PKG and Interconnect COM Impact Analysis and “What-ifs”

Liav Ben-Artzi - Marvell Technology Group

- This presentation will provide a correction for the PKG return loss as included in the COM code.
- It will be shown that given the corrected return loss, COM result increases and KR4 targets can be met.
- This presentation also provides resolution for comments: 44-48; 50-54; 56-58

TP0a/TP5a Return Loss Measurements Limit

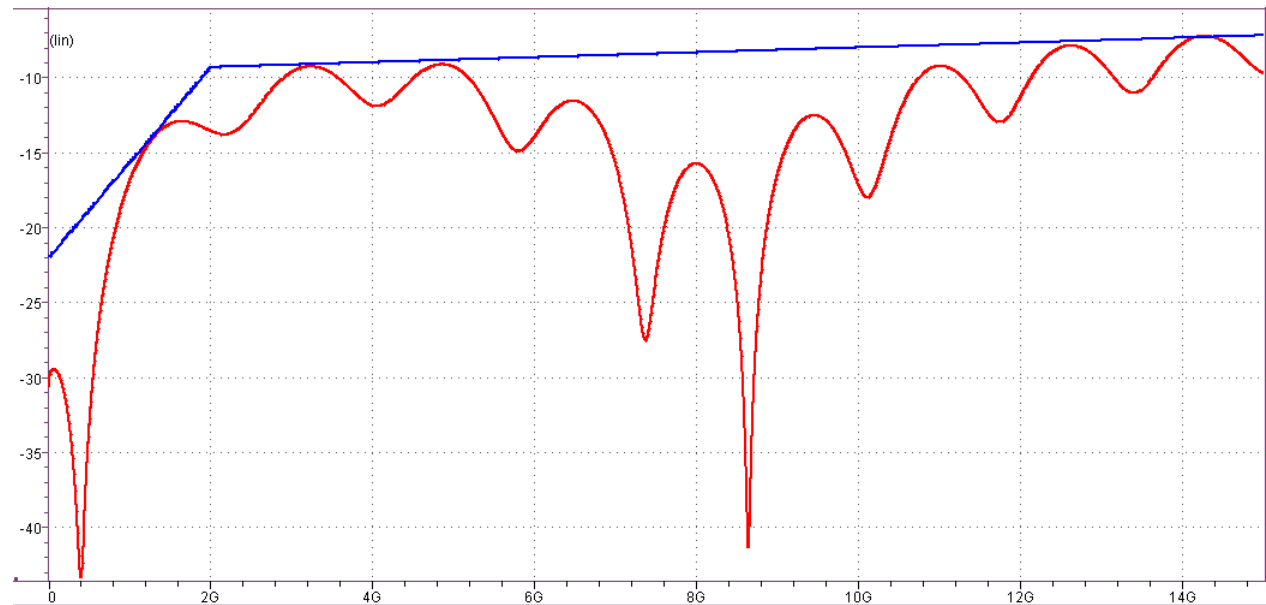
- The return loss at TP0a/tp5a as measured through the test fixture should meet:

$$6.25 * f - 22$$

$$0.05 \leq f \leq 2$$

$$0.163 * f - 9.62$$

$$2 \leq f \leq 13 \text{ (10 for KP4)}$$

A Spotlight on Interconnect Return loss

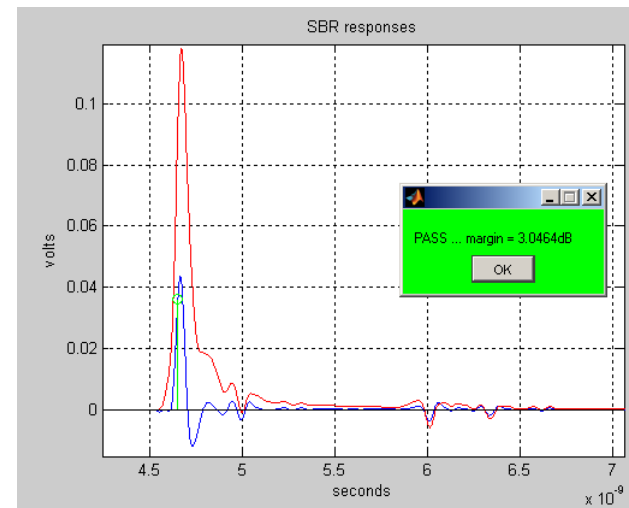
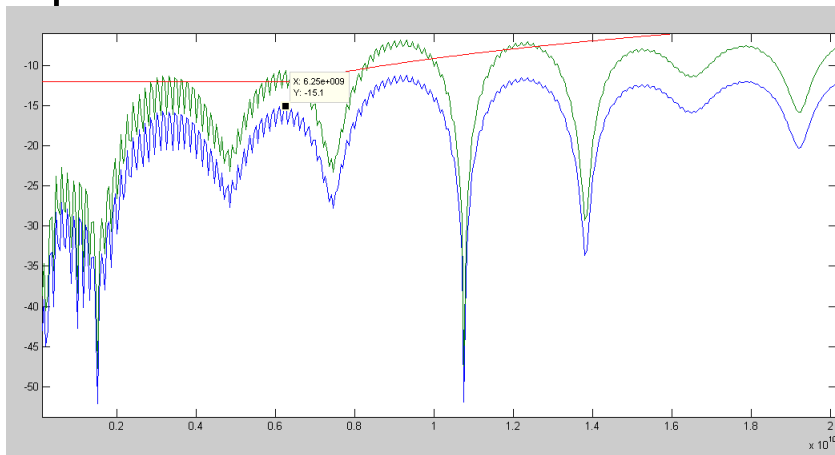
- FCI_CC_Long_Link_Pair_15_to_Pair_7 Returns a failing COM number.

- Update the interconnect RL...

The Package Return Loss is Based on Physical Design Realities

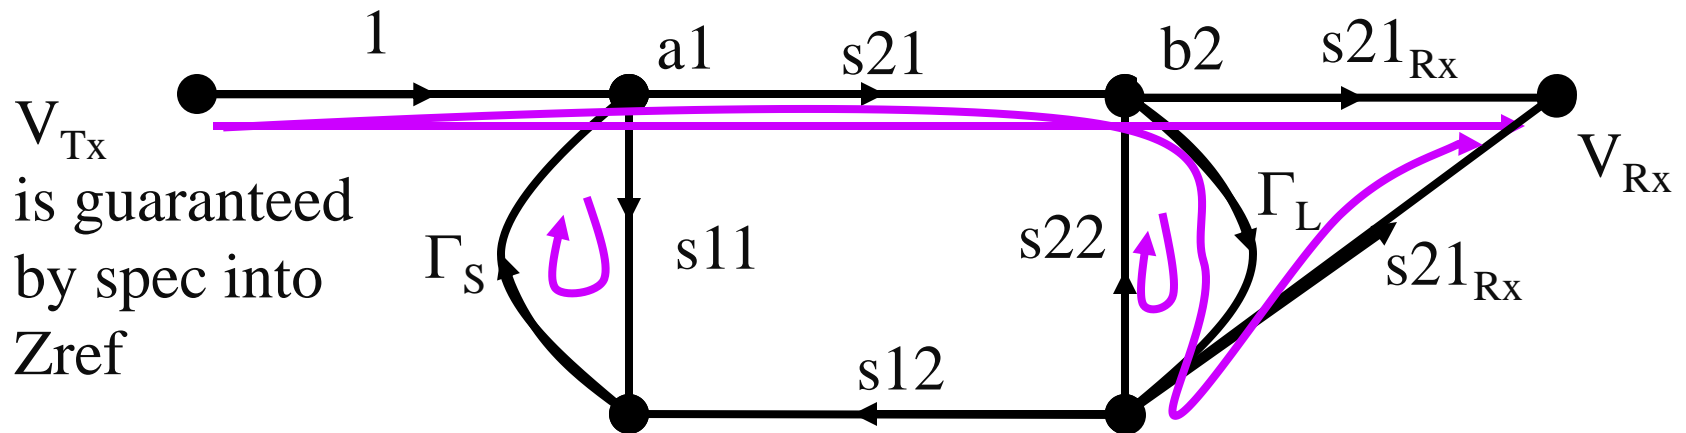
- Assumed capacitance was taken from numerous former presentations (250fF).
- The die and ball discontinuities influence the return loss curves.
- The return loss curves are highly influenced by the discontinuities at the ball and the die and represent no added discontinuity along the package trace.
- The return loss curves take into account package traces of various length.
- Conclusion: The suggested return loss is based on ball-discontinuity extraction and die parasitic capacitance.

Main Observation @ $1e-12$ (return loss impact)

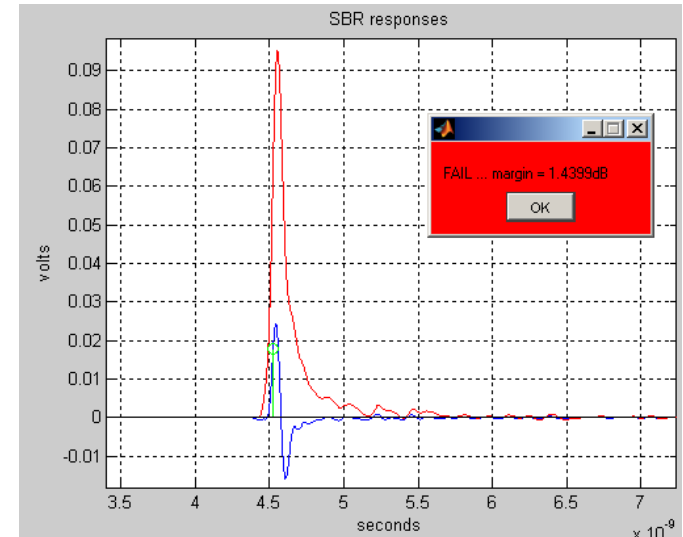
- Running the IBM 30dB interconnect – (meets the interconnect RL with minor violations) + OIF package / D1.2 package return loss returns a failing COM result w/o FEC.
- → Specifying the OIF targets as PKG and interconnect return loss limits does not guarantee a passing COM result.
 - Note: no package insertion loss model was included in the analysis.

IBM30dB - An Improved PKG Return Loss

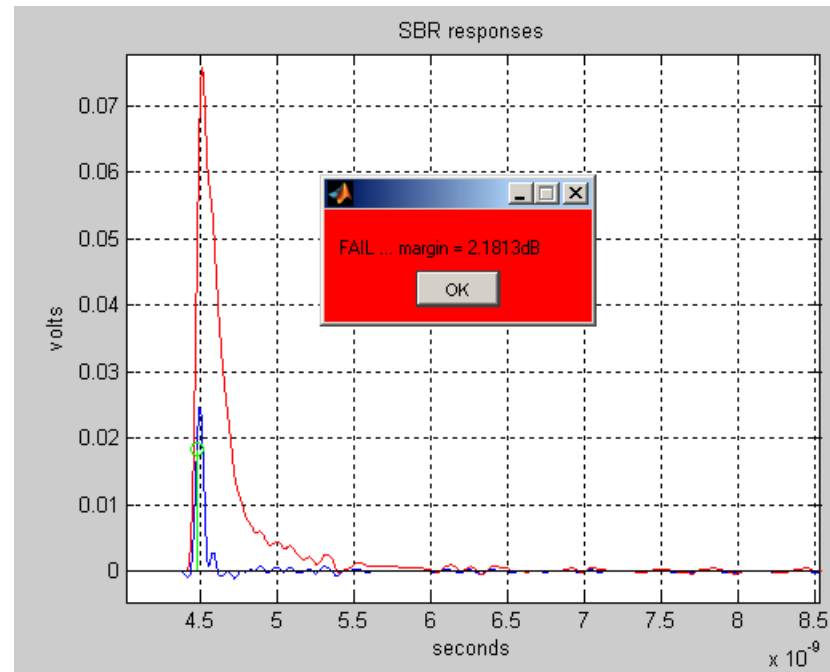
- Running the IBM 30dB channel with an improved (low frequency) PKG return loss (no PKG ins loss) returns a failing COM result (2.18dB)

FCI - Would a 200fF related PKG return loss help?

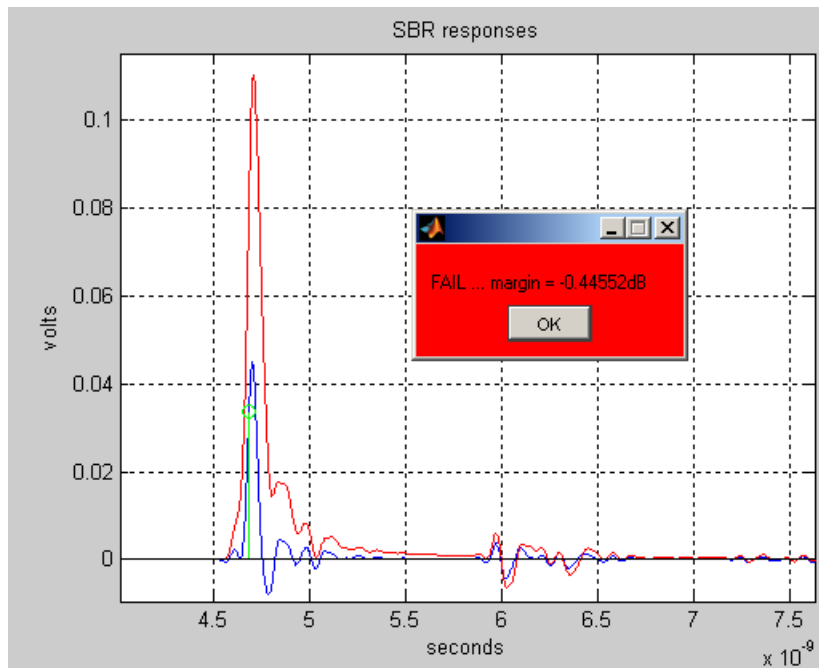
- Changing the PKG return loss to a “better” one that correlates to 200fF @ the die:

- No major effect...

FCI - Is the PKG model the problem here?

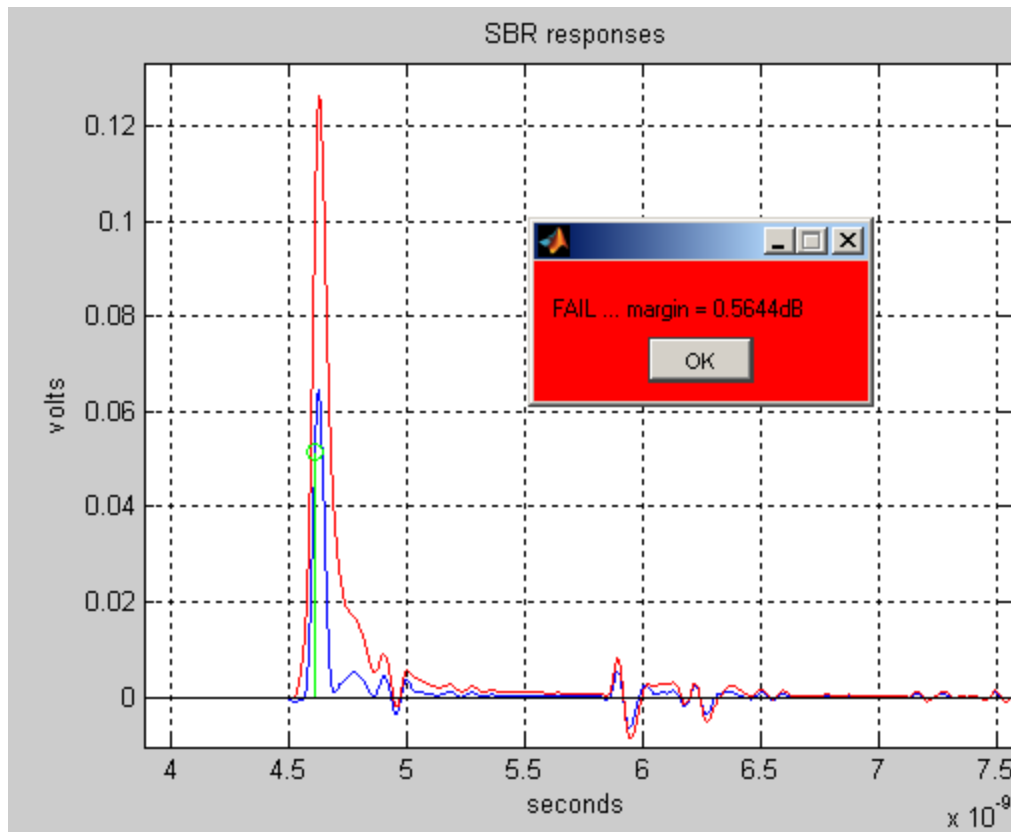
- No! low effect of the PKG model

FCI - Pre-Cursor TAP Increased

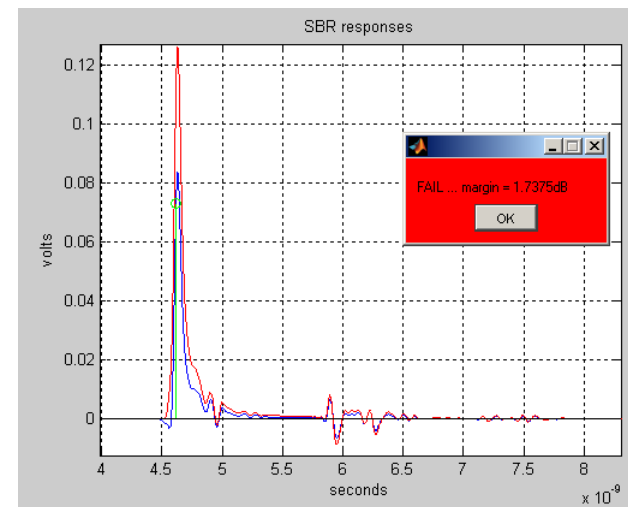
- No PKG IL, Better PKG RL, pre-cursor tap limited to -0.3 instead of -0.1...
- Still not enough...
- Most of the analysis was performed with VTF = 1 (which is easier), but still it was not enough...
Will be discussed on a later slide.

- *Conclusion: Need to tighten Return loss or rely on FEC...*
